Access Compliance Report

Public Rights-of-Way

Intersection ID: 50588	Main Street: BENDING_BRANCH_RD	Cross Street: DOWNY_BIRCH_RD	Location: SW
ADA ID: 95C47CE06DEB	Ramp Type: Perp	Initial Pass/Fail: Fail	Overall Compliance: No
Severity Score: 22.5			
Codes/Mitigation Info/Possible Solution		Field Measurements/Component Compliance

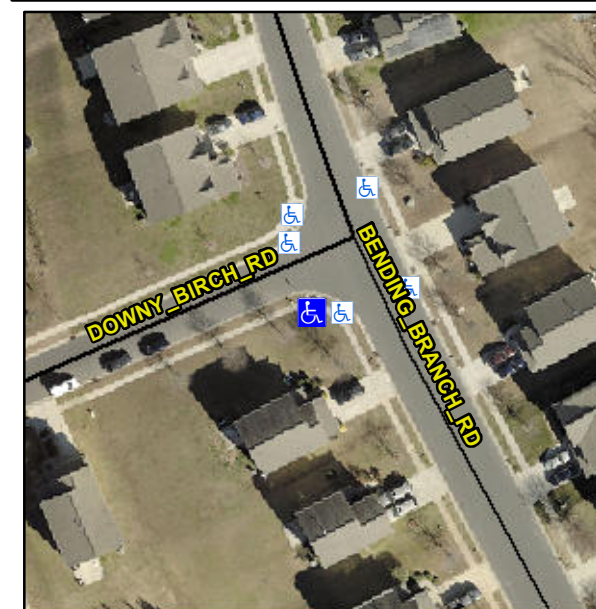
Not Found, R304.5.1, R304.2.2, R304.5.3

Compliance	Description	Data	Compliance	Description	Data
N/A	Ramp Length (in)	46.0	No	Ramp Slope (%)	10.9
No	Ramp Width (in)	47.5	No	Ramp XSlope (%)	4.1
N/A	Flare Type LT	N/A	N/A	Flare Type RT	N/A
N/A	Flare Slope LT (%)	N/A	N/A	Flare Slope RT (%)	N/A
N/A	Flare Traversable LT?	N/A	N/A	Flare Traversable RT?	N/A
N/A	Landing Length (in)	N/A	N/A	DWS Provided?	N/A
N/A	Landing Width (in)	N/A	N/A	DWS Contrast?	N/A
N/A	Landing Slope (%)	N/A	N/A	DWS Length (in)	N/A
N/A	Landing X Slope (%)	N/A	N/A	DWS Full Width?	N/A
N/A	Landing Curb? (Y/N)	N/A	N/A	DWS Offset (in)	N/A
N/A	Shared Landing?	N/A			
N/A	Gutter Ponding?	N/A	N/A	Gutter Slope (%)	N/A
N/A	Gutter Lip Ht (in)	N/A	N/A	Gutter X Slope (%)	N/A
N/A	Painted X Walk1?	No	N/A	Painted X Walk2?	N/A
	X Walk 1 Direction	To N		X Walk 2 Direction	N/A
N/A	X Walk 1 Width (in)	N/A	N/A	X Walk 2 Width (in)	N/A
	X Walk 1 Slope (%)	0.9		X Walk 2 Slope (%)	N/A
	X Walk 1 X Slope (%)	2.9		X Walk 2 X Slope (%)	N/A

Remove & Replace Entire Ramp.
